HISTORIC AND DESIGN REVIEW COMMISSION

HDRC CASE NO: 2026-101
ADDRESS: 218 ADAMS ST
LEGAL DESCRIPTION: NCB 943 BLK 1 LOT 13
ZONING: RM-4, H
CITY COUNCIL DIST.: 1
DISTRICT: King William Historic District
APPLICANT: Nick Handel
OWNER: Nick Handel/Abby M & Nickolas G Handel
TYPE OF WORK: Construction of a rear accessory structure
APPLICATION RECEIVED: May 31, 2026
60-DAY REVIEW: July 30, 2026
CASE MANAGER: Adrian Gallegos

The applicant is requesting a Certificate of Appropriateness for approval to construct an approximately 948 sf 2-story detached garage featuring cement fiberboard siding and a standing seam metal roof at the rear of the property.

FRONT ELEVATION

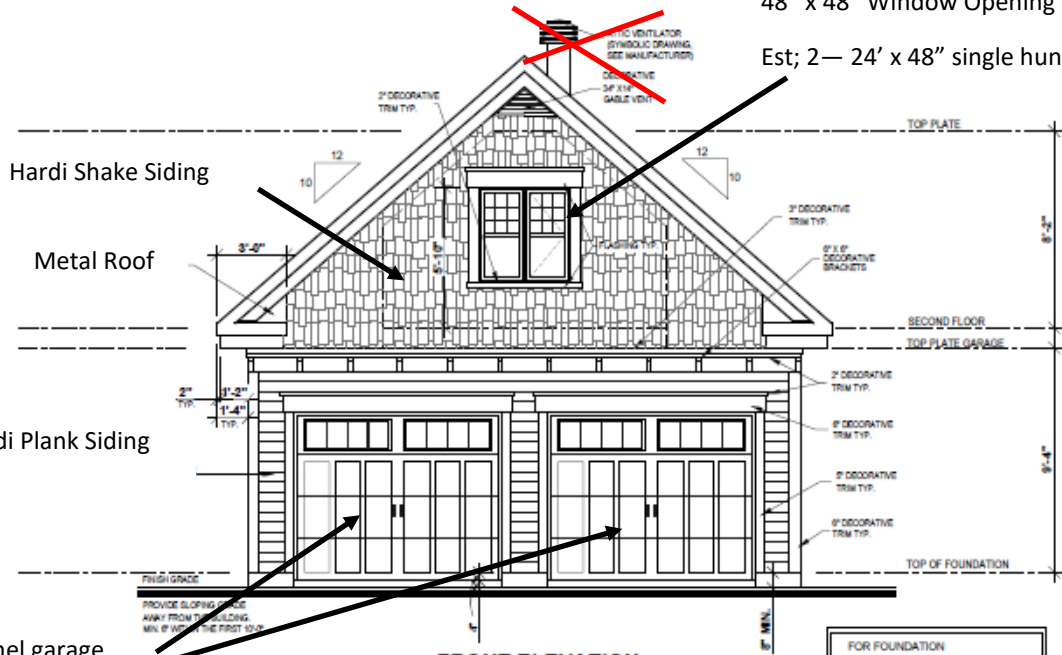
- g. **ARCHITECTURAL DETAILS (FENESTRATION PATTERN)** – The applicant has proposed paired one-over-one single-hung windows on each façade of the rear accessory structure as a well as one rear-facing door opening. New Construction 2.C.i. related to window and door openings stipulates to incorporate window and door openings with a similar proportion of wall to window space as typical with nearby historic facades. Staff finds the proposed fenestration pattern generally appropriate.

- iv. That the applicant installs a fully wood garage door or a garage door with a design that mimics wood construction and features a smooth finish without a faux wood grain texture. The garage doors shown in the renderings appear to meet this stipulation, but final garage door specifications must be submitted to staff for review and approval prior to the issuance of a Certificate of Appropriateness.

- i. That the applicant installs wood or aluminum-clad wood windows that meet staff's standard window stipulations and submits updated specifications to staff for review and approval. The windows should feature an inset of two (2) inches within facades and should feature profiles that are found historically within the immediate vicinity. Meeting rails must be no taller than 1.25" and stiles no wider than 2.25". White manufacturer's color is not allowed, and color selection must be presented to staff. There should be a minimum of two inches in depth between the front face of the window trim and the front face of the top window sash. This must be accomplished by recessing the window sufficiently within the opening or with the installation of additional window trim to add thickness. Window trim must feature traditional dimensions and architecturally appropriate sill detail. Window track components must be painted to match the window trim or concealed by a wood window screen set within the opening. An alternative window material may be proposed, provided that the window features meeting rails that are no taller than 1.25" and stiles no wider than 2.25".

- ii. That the applicant provides full window and door specifications for review by staff prior to the issuance of a Certificate of Appropriateness.
- iii. That the applicant installs a standing seam metal roof featuring panels that are 18 to 21 inches wide, seams that are 1 to 2 inches high, a crimped ridge seam, and match the current finish or a standard galvalume finish. Panels should be smooth without striation or corrugation. Ridges are to feature a double-munch or crimped ridge configuration; no vented ridge caps or end caps are allowed. All chimney, flue, and related existing roof details must be preserved. An inspection must be scheduled with OHP staff prior to the start of work to verify that the roofing material matches the approved specifications.
